RE: 18-1546-EL-BGN Nestlewood Solar Facility Local Public Hearing

Nestlewood Solar I LLC seeks Board approval of an 80 megawatt solar electric generating facility located in Clark Township, Brown County and Tate Township, Clermont County, approximately 3 miles west of Hamersville, Ohio.

Below is a picture of a solar farm presented by Nestlewood Solar I LLC at the Public Informational Meeting November 7, 2018. As can be seen, solar farms have no or little ground cover vegetation and rain water will just run off as described above.

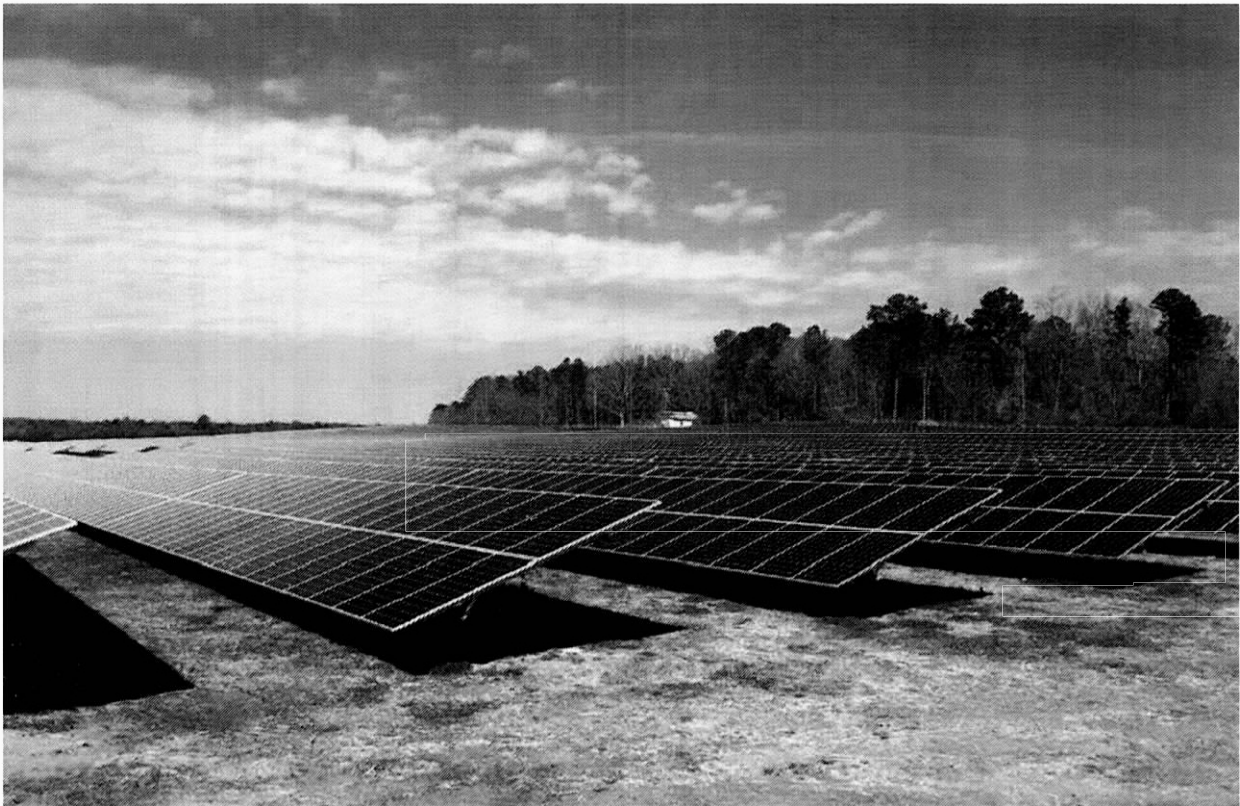
It is therefore requested that, if granted approval, Nestlewood Solar I LLC be ordered to construct on site a storm water reservoir that collects the rain water runoff and discharges it in a controlled manner.
